<b>Title:</b>	<b>V01.06.00 user firmware and V01.09 power firmware release</b>		
<b>Product:</b>	Mentor MP	<b>Issue Date:</b>	5-December-2011
<b>Variant:</b>	N/A	<b>Date Codes:</b>	
<b>Category:</b>	Product changes - Software	<b>Manuals affected:</b>	Yes
<b>Issued By:</b>	P.Slater	<b>Priority:</b>	Normal

**Two Drives in 6 Pulse Parallel Operation**

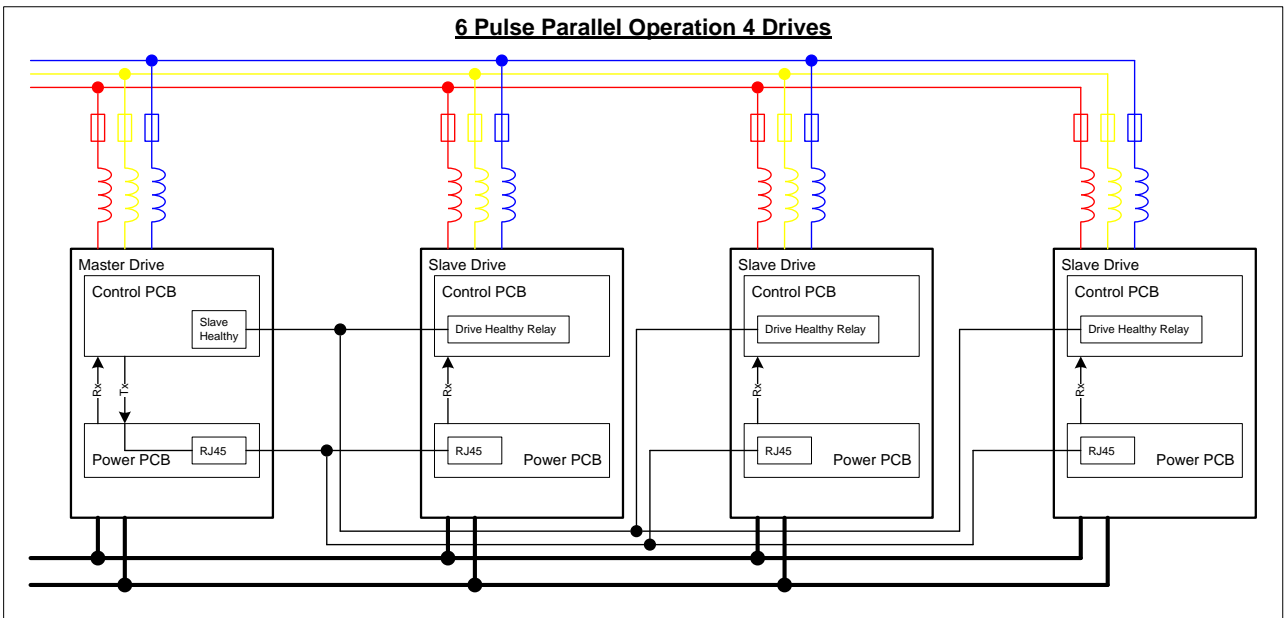
Parallel operation implemented (Parameter 5.43 - Armature Mode)

Number	Text	Description
0	Std	Normal (1Q or 4Q)
1	P.1br	Parallel - 1 bridge. Current loop gains reduced by half. No bridge lock out.
2	P.2br12P	Parallel - 2 bridge - 12 pulse
3	P.2br24P	Parallel - 2 bridge - 24 pulse
4	FrEE	Not used
5	FrEE	Not used
6	FrEE	Not used
7	P.cont	Parallel 6P master
8	P.SLAuE	Parallel 6P slave

**Slave Healthy**

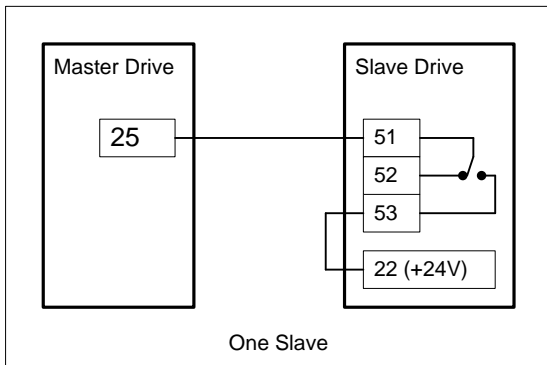
The master drive must know the state of health of the slave or slaves in a 6 pulse parallel system. This can be achieved using digital IO or a communication module. When there are multiply slaves the master can be setup to use 1 bit to check the health of the slave or multiply bits.

**One Slave**

Set 08.22 to 05.45.

**Multiply Slaves One Monitor Bit**

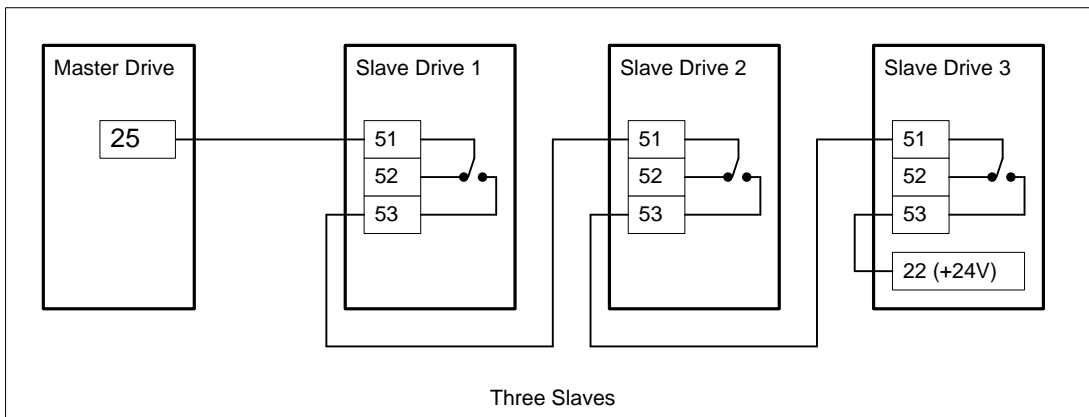
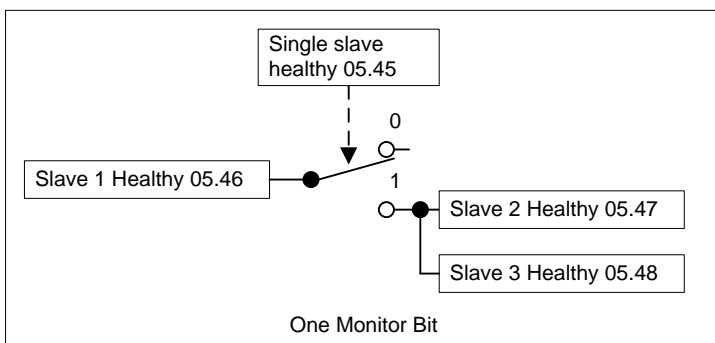
In this mode 05.45 needs to be set to a 1. Set 08.22 to 05.45.

Multiply Slaves Signal Multiply Monitor Bits

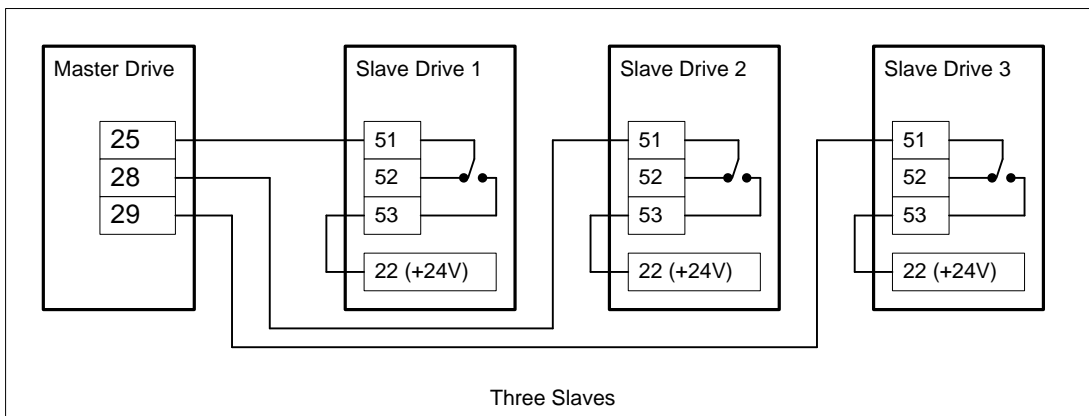
Set 08.22 to 05.45, 08.25 to 05.46 and 08.26 to 05.47.

Slave Healthy Bits

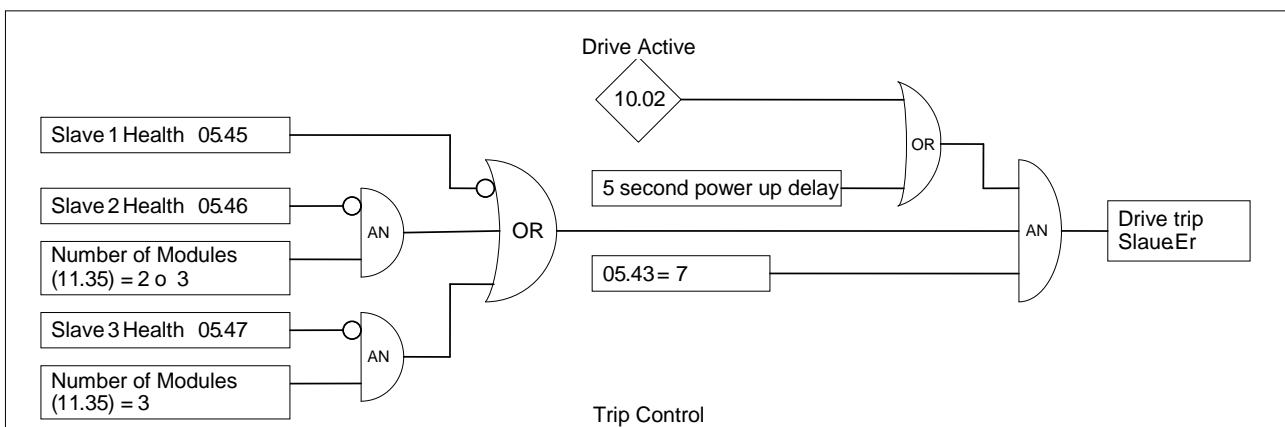
The loss of slave healthy will trip the drive. This trip can not masked as the slave trip will be an important trip for example over temperature.

The 5 second power up delay is to allow the whole system to power up before checking that the slaves are healthy. If the system takes longer than 5 seconds to power up DUP could be used to reset the trip. The Drive Active is used to ensure that the slave healthy is checked when the master is given a run command within the 5 second timeout.

**Set up Sequence**

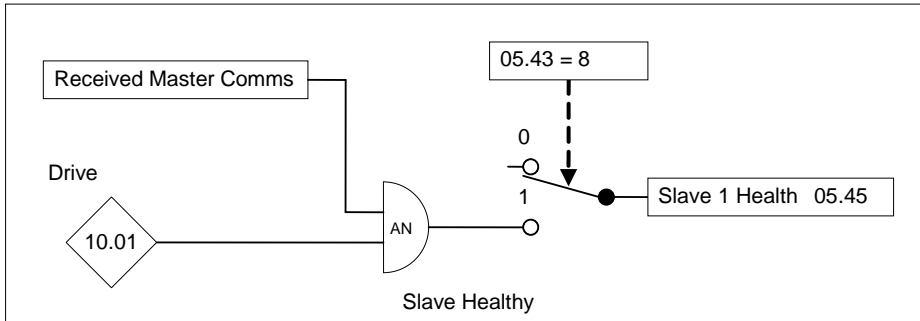
To configure a drive as the master drive in a 6 pulse parallel system set

- Configure IO dependant on how the slave healthy is to be received.
- Set 05.43 to 7 (P.cont).
- Set 11.35 to the number of slaves in the system.
- Reset the drive.
- 11.32 will now be the number of slaves in the system plus one times the drive rating.

**Brake control function**

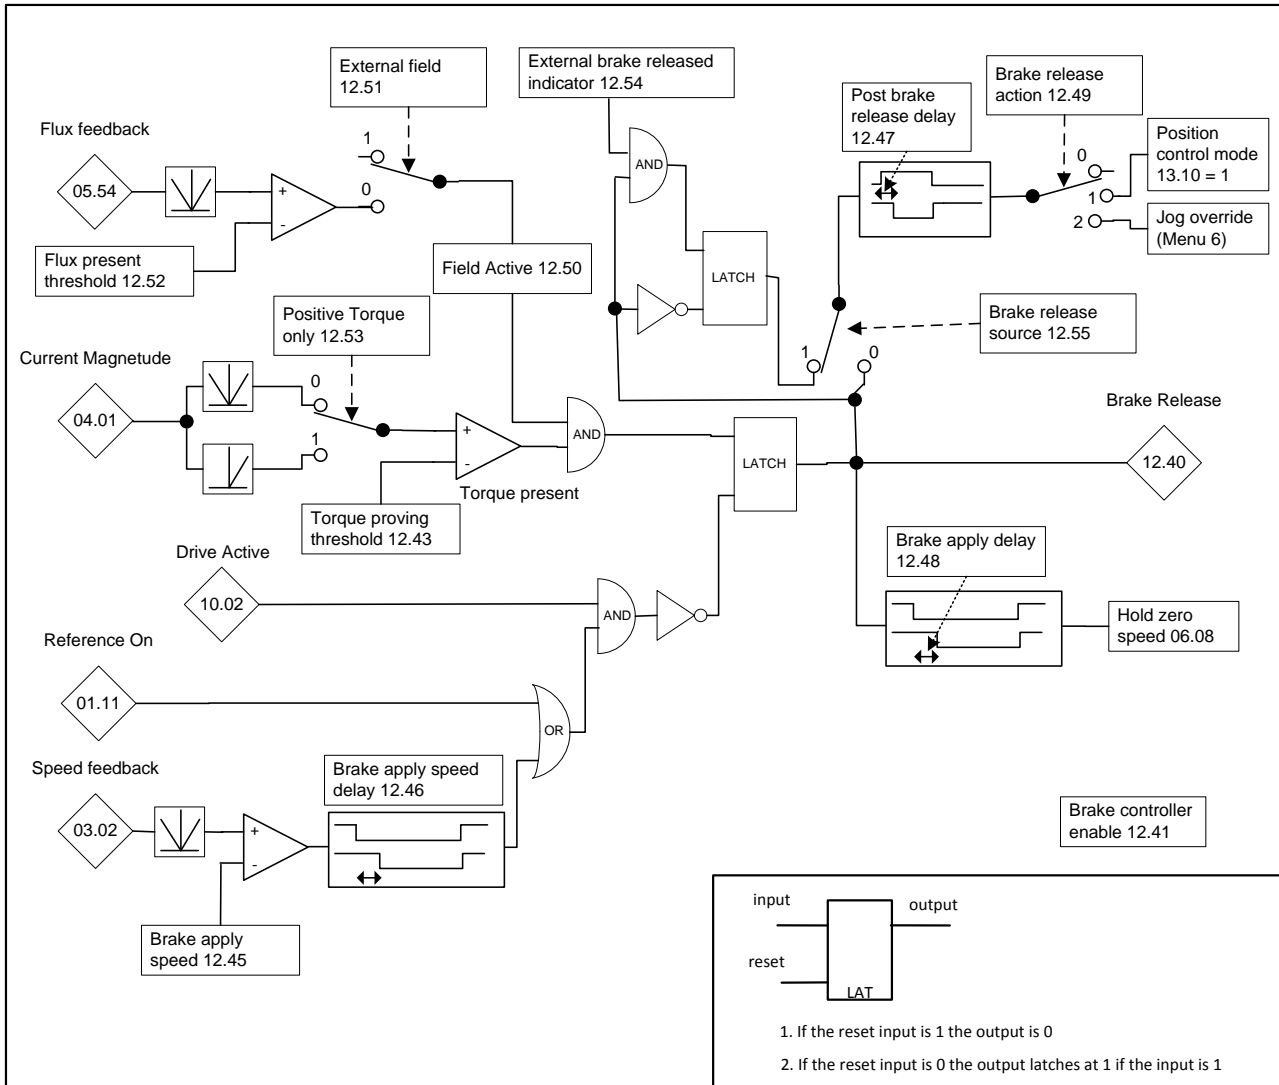
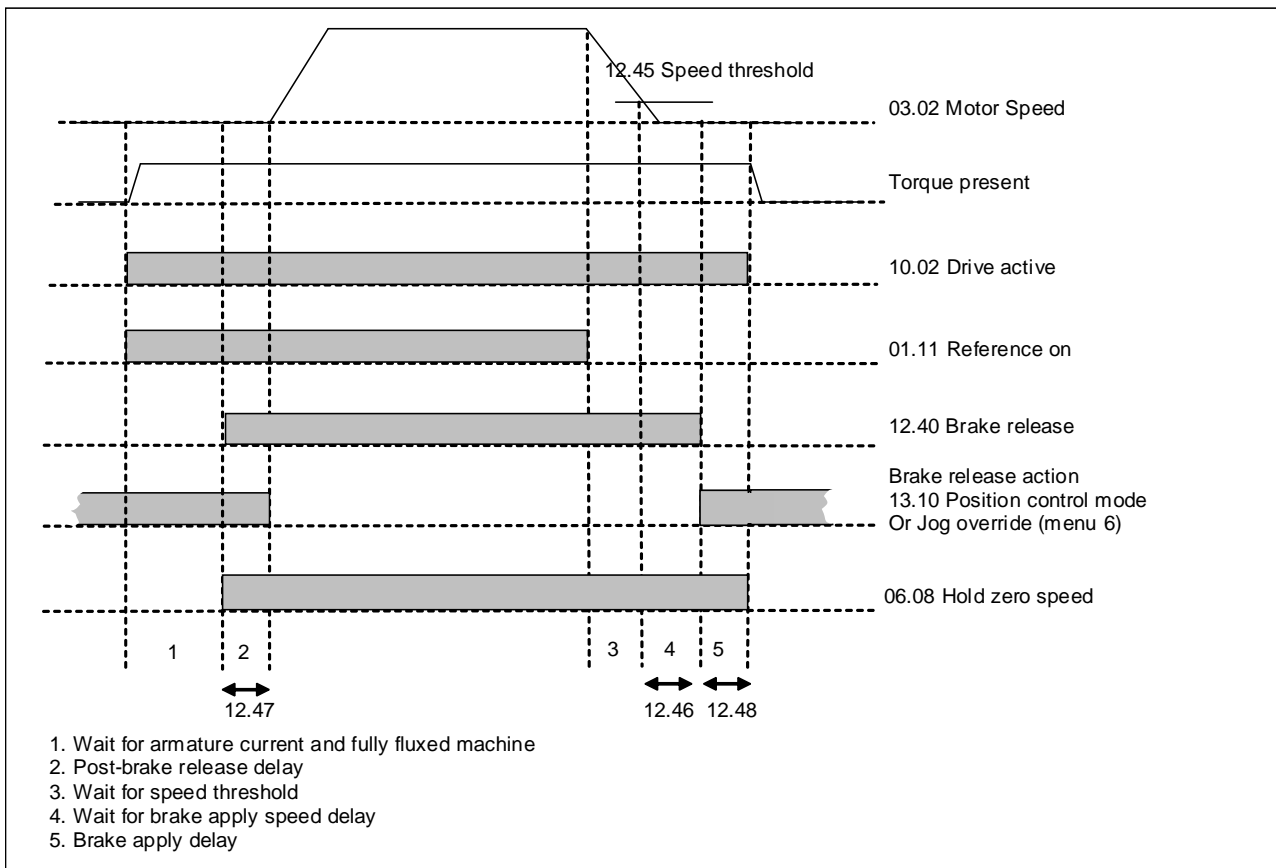
The brake control function can be used to control an electro-mechanical brake via the drive digital I/O.
